Request for Class II Permissive Change(C2PC)

FCC ID: VG8EM134AYYMW

Date: 2023-11-20

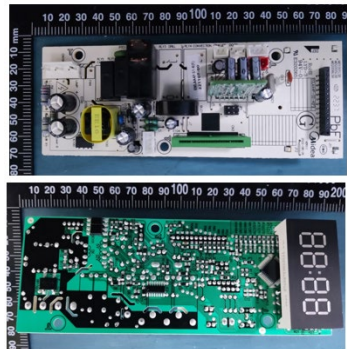
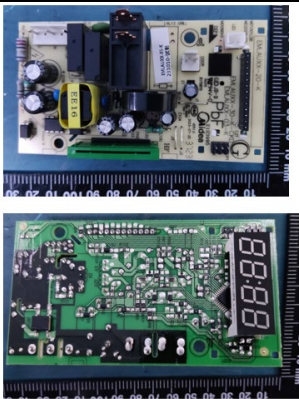
No.:	Original	New	Difference(s)
1			Front-panel and keypad: 1. Updated keypad button to accommodate child lock function (Child resistant oven door function); 2. Updated front-panel and keypad's silkscreen.
2			Mother board: 1. Modified the peripheral circuit (non-RF circuit) and some individual components and PCB layout. The magnetron and other circuit are exactly same as before. 2. Added a solenoid valve locking mechanism, the original is not.
3	N/A	N/A	Updated interlocking assembly.
